To: Rob Balland, Paramounte Engineering
From: Brian Chambers, Assistant Director, 910.342.2782
CC: File;
Date: 7/17/2023
Re: The Avenue TRC Rev 2

Project Name: Carroll at the Avenue

Project Name: **THE AVENUE**

SIGNAGE AND PAVEMENT MARKING PLAN:

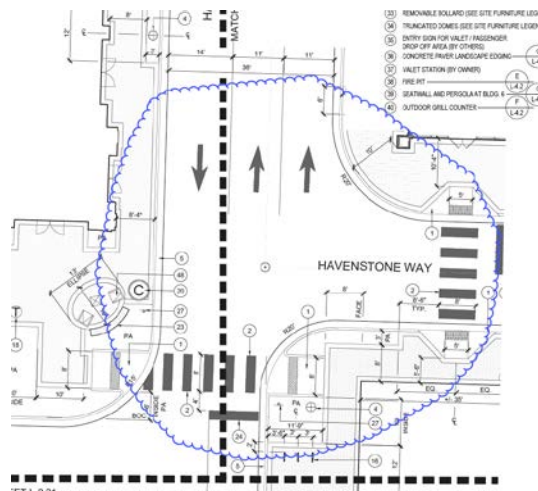
1. Provide a separate sheet for signage and pavement marking plan for all the internal private ROWs showing all proposed traffic control signs, street name signs, and related pavement markings locations and types for all the proposed ROWs. [[CofW Sign Specification and Installation Guide](#)] [[Provide a reference for each sign from MUTCD](#)]. Plan will be reviewed by Signs & Markings Engineer Manager.
2. Pavement markings for crosswalks on private streets are not required to be high visibility. Standard parallel bars may be installed instead.
